SIDE ENTRY WITH RIGHT REAR EXIT
OPTION "D"

STORE # 11562

APPROVED WITH CONDITIONS

2008 PROTOTYPE CRITERIA SET PLAN "D" - ADDENDA RELEASE 5/19/08

TITLE SHEET OPTION "D"

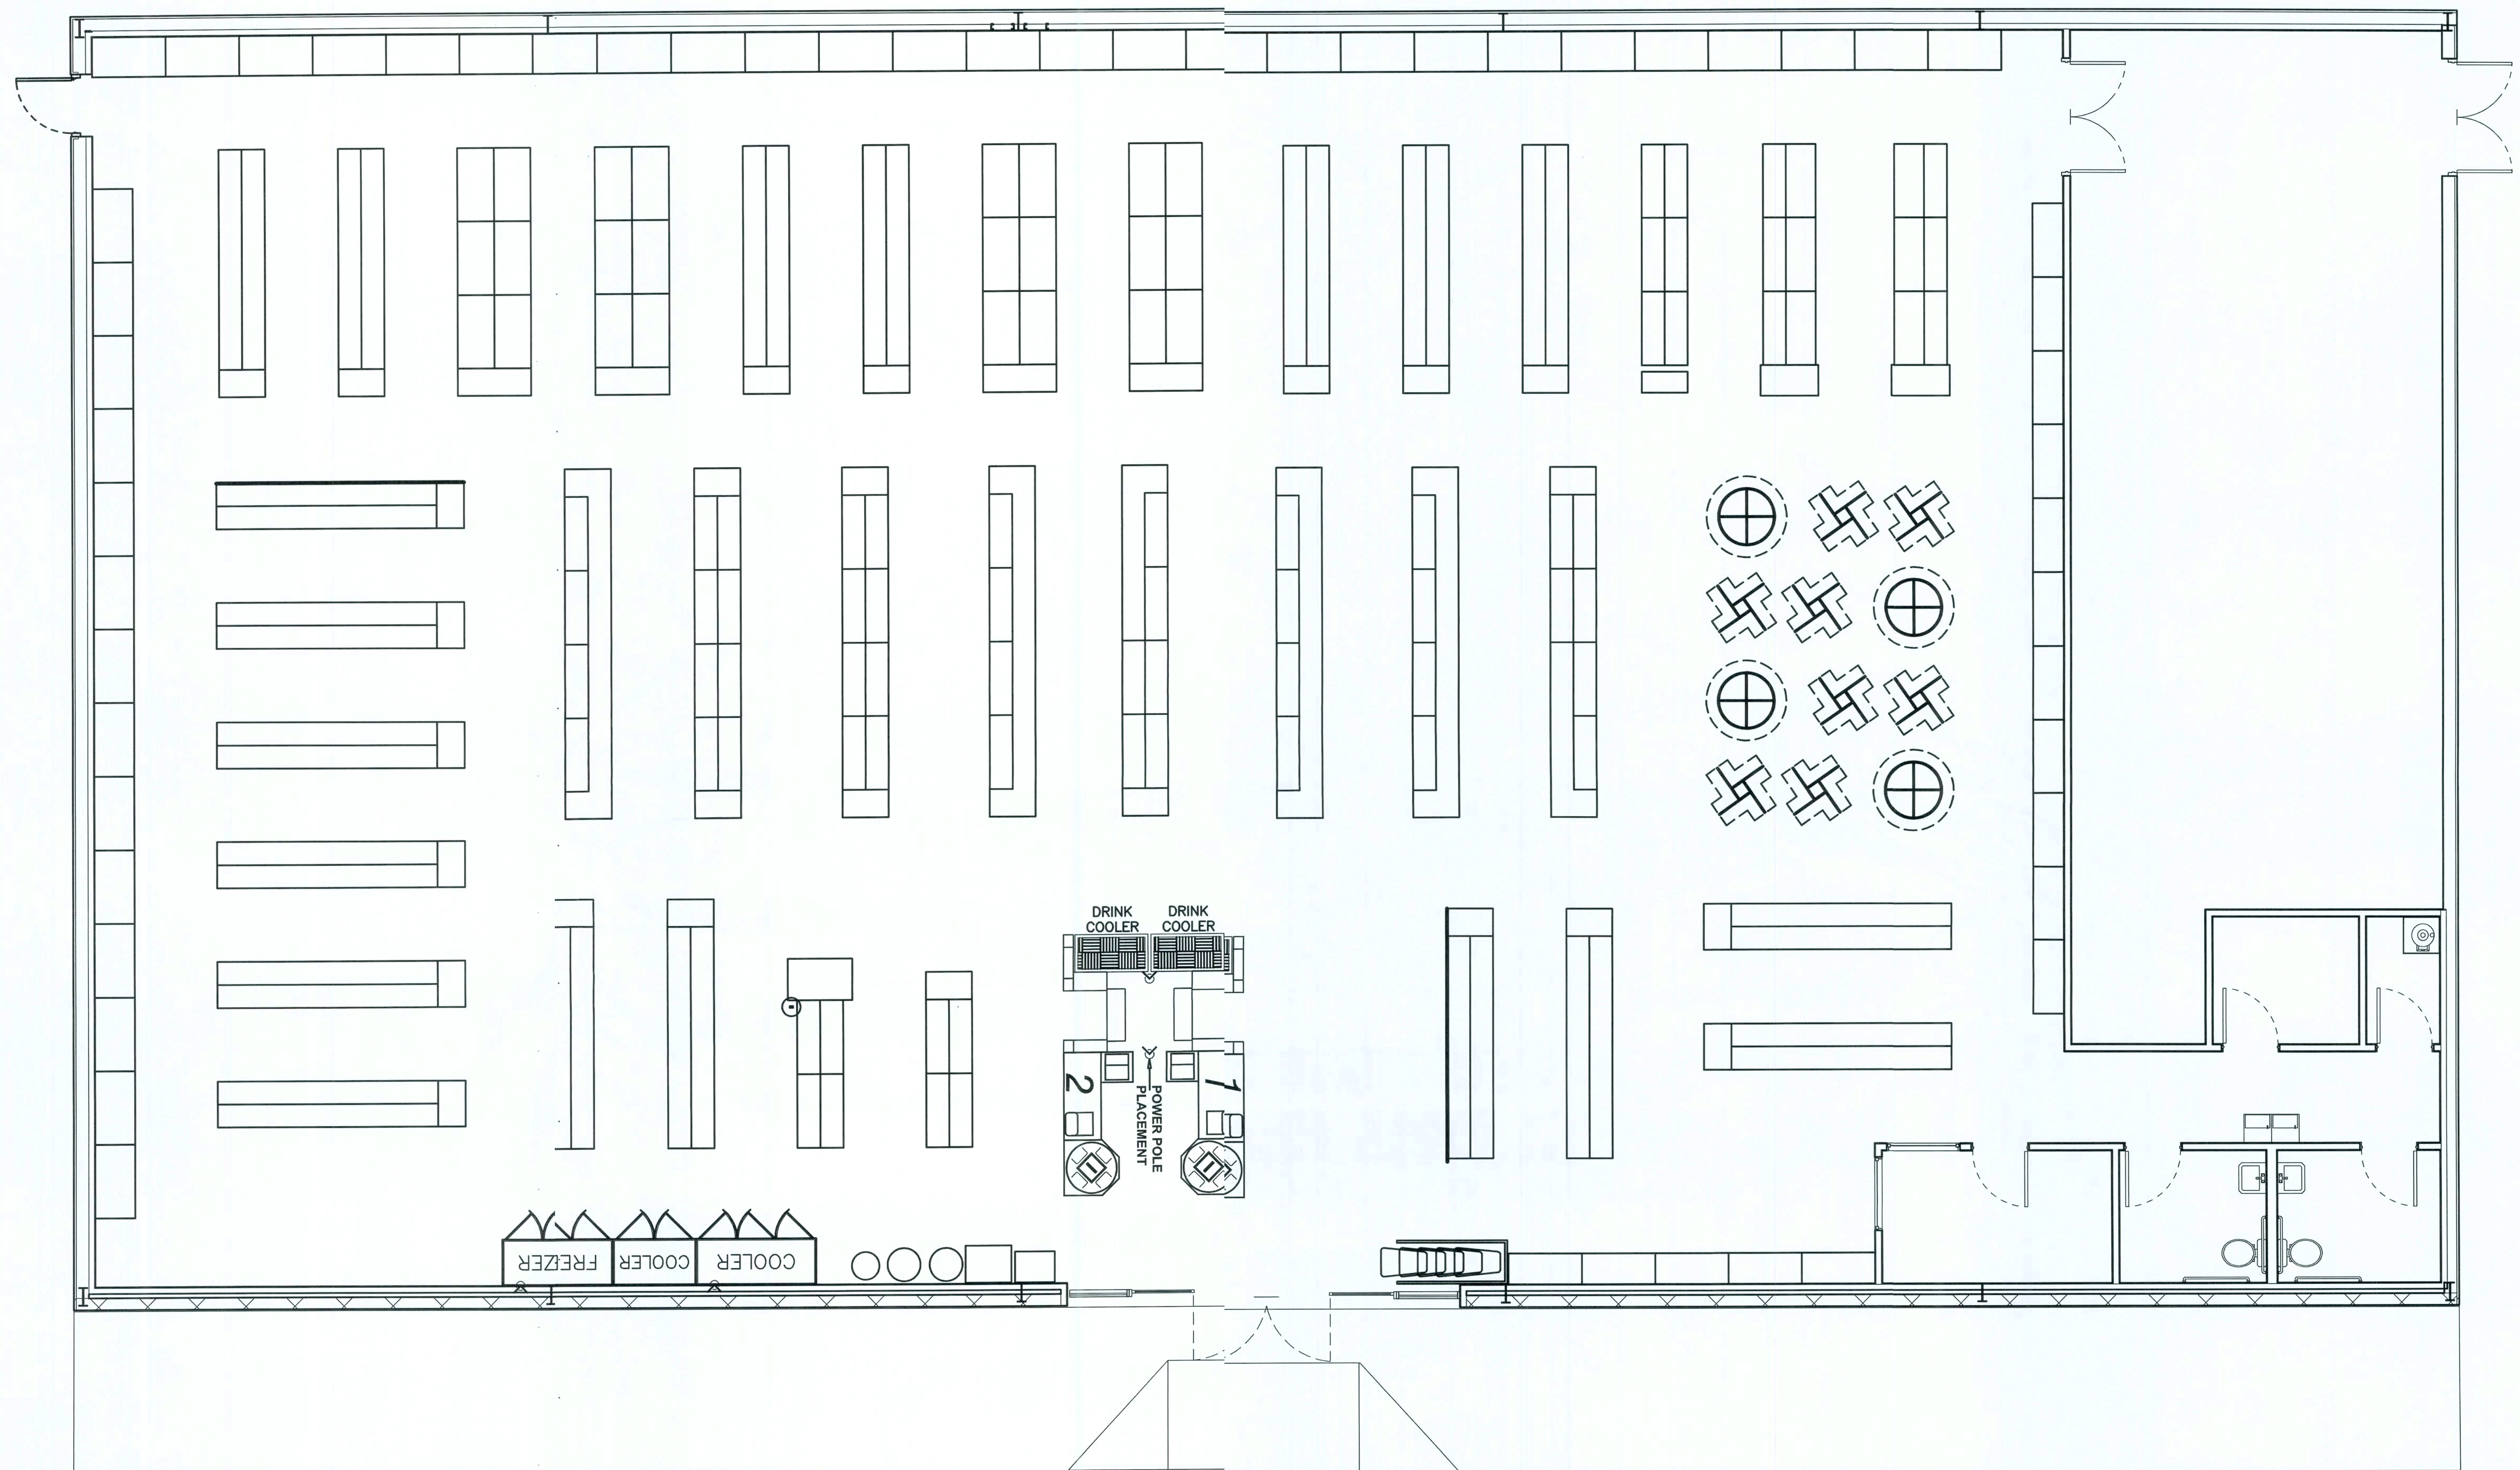
UPDATE WITH ATTACHED VENDOR LIST

FIXTURE PLAN OPTION "D"

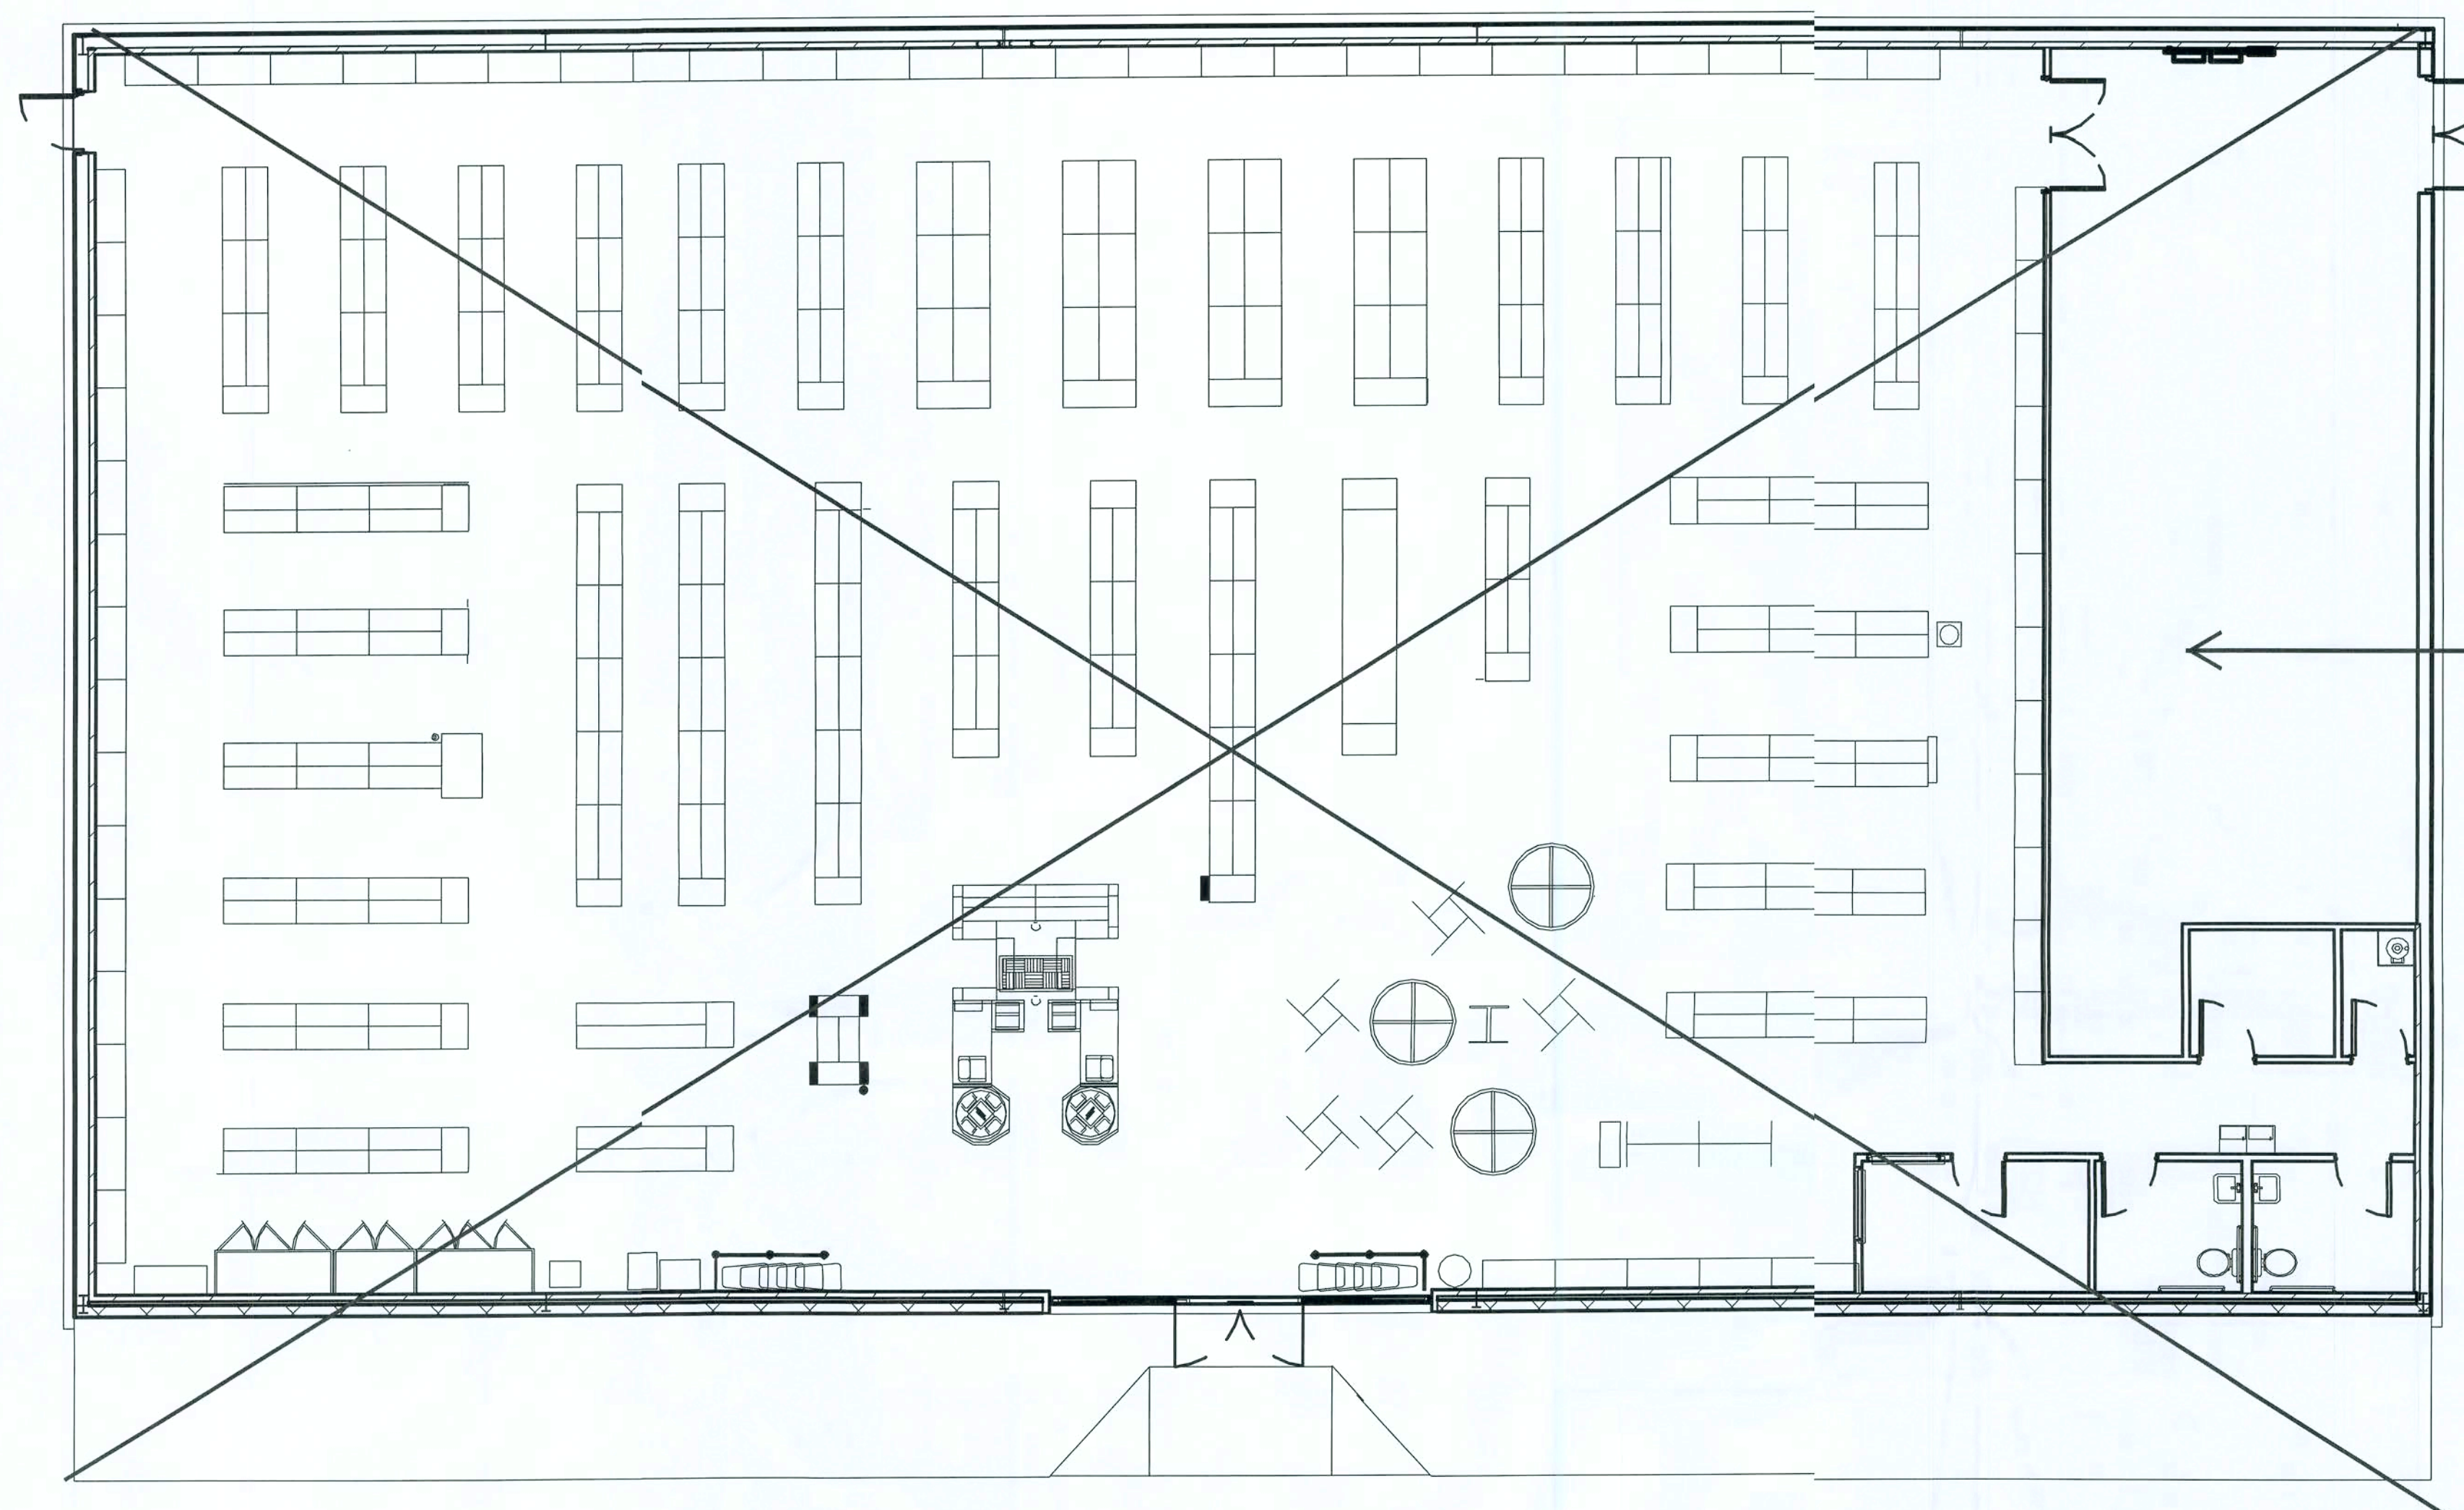
UPDATE WITH ATTACHED REVISED
FIXTURE PLAN

SCHEDULES OPTION "D"

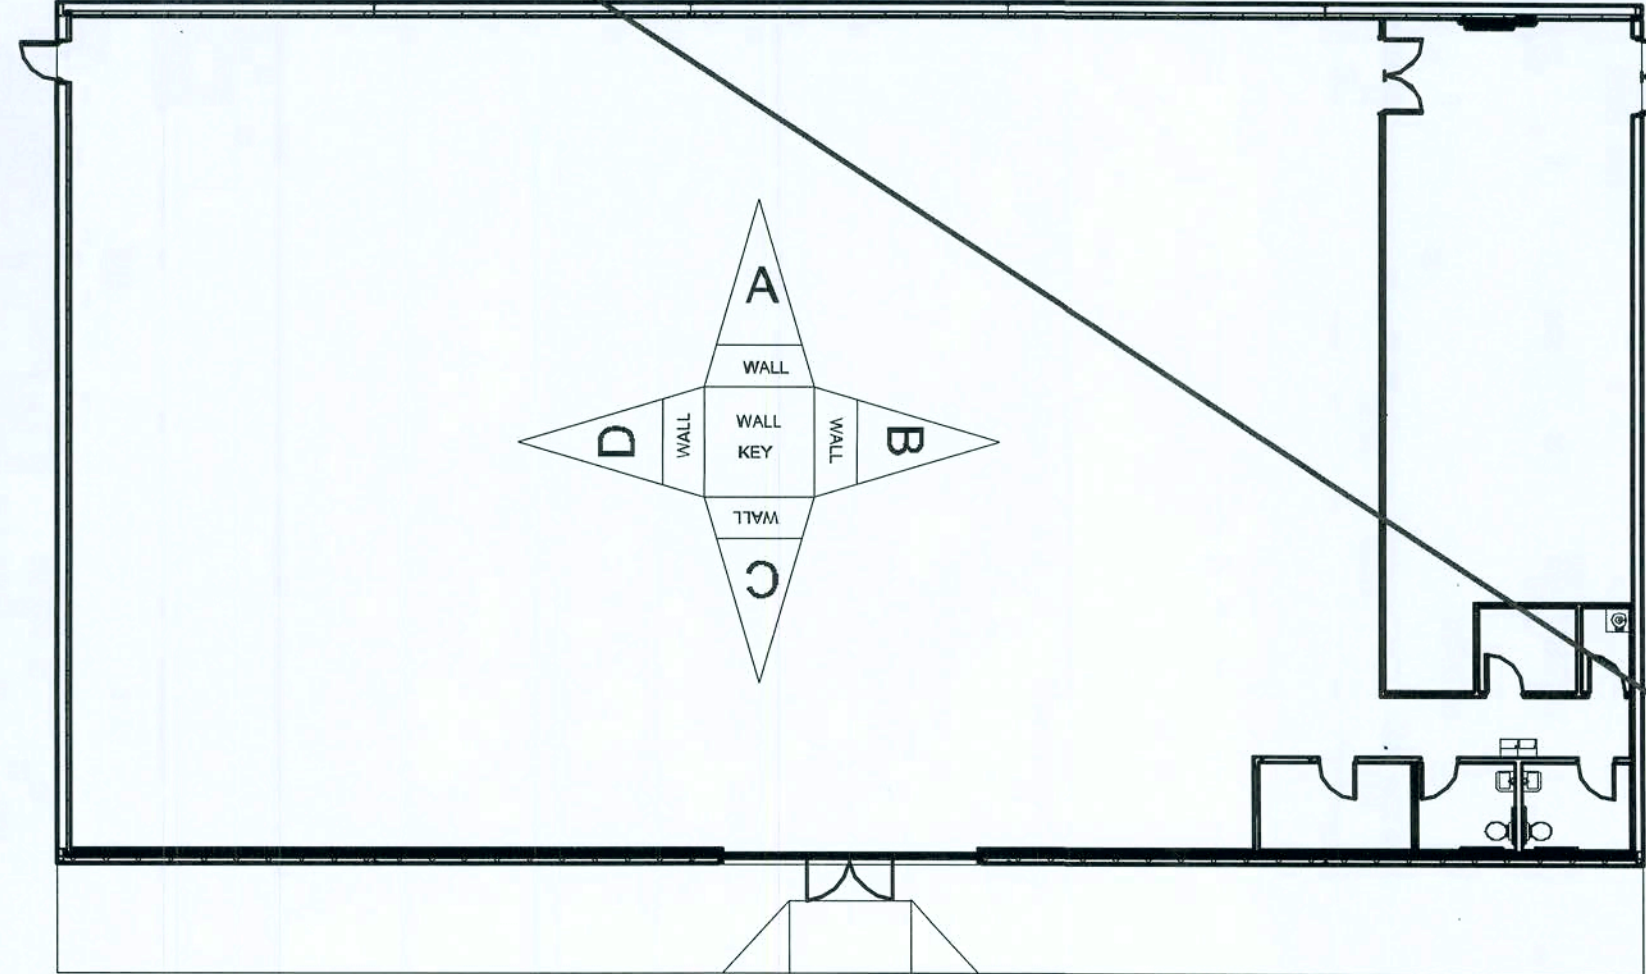
UPDATE THIS SHEET WITH
ATTACHED REVISED SCHEDULES
